Analysis of NGSO MSS Feeder Link Interference Into Terrestrial Point-to-Point Links

Analysis of Interference between Terrestrial Point-to-Point Links and 4 GHz Geostationary Receive Earth Stations

In the Matter of)	
)	
Preparation for International)	IC Docket No. 94-31
Telecommunications Union World)	
Radiocommunications Conferences)

LATE FURTHER REPLY COMMENTS ON SECOND NOTICE OF INQUIRY

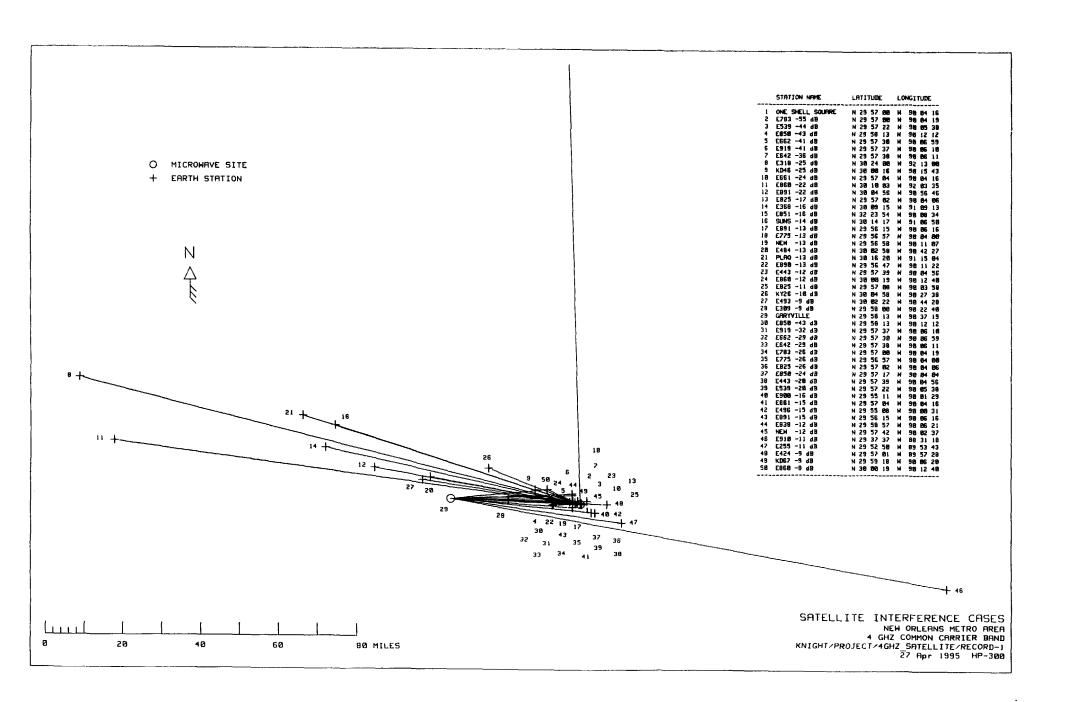
Figure 1 shows the results of the New Orleans coordination. The site locations and antenna heights of an existing lower 6 GHz microwave path from One Shell Square to Garyville were used for the test path, assuming 4 GHz antennas and radio equipment. A total of 48 interference cases were identified that exceeded the minimum earth station interference criteria. Each line on the plot shows an interference path. The table on the right lists the affected earth stations and the severity of each interference case in dB. The worst cases were 55 and 44 dB above the minimum acceptable interference.

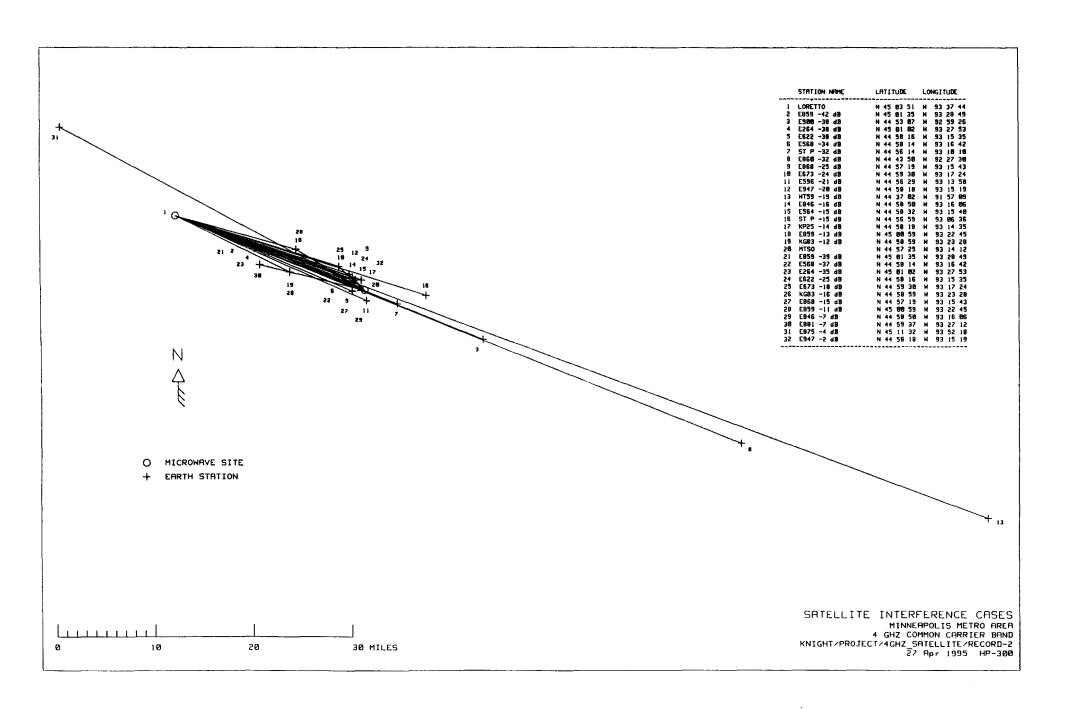
Figure 2 shows the results of the Minneapolis coordination. An existing cellular path from Loretto to MTSO was used as the test path. The coordination identified 30 interference cases. The worst cases were 42 and 39 dB above the interference limit.
